TECHNICAL IMPROVEMENT
No-SC/CV/TI/14-15_393
Dt.-12.02.2015

SUB GROUP: DSL FL
Model : Optima & Maxima

IMPROVEMENT: .MODIFIED FRONT MUDGAURD- MAXIMA & OPTIMA DSL

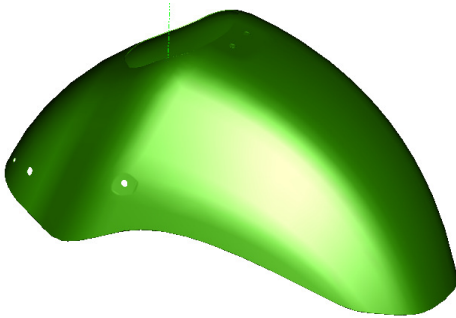
Reason for Change: To improve quality- better resistance to corrosion

Modification details: FRONT MUDGAURD- ZINC COATED SHEET-

1. Material changed to cold rolled steel sheet/strip,
2. Hemming region Improved.

Part No Details: Serviceable part no: BB161099-Front mudguard remains same & is interchangeable. ED coated part no is **52BB0075**
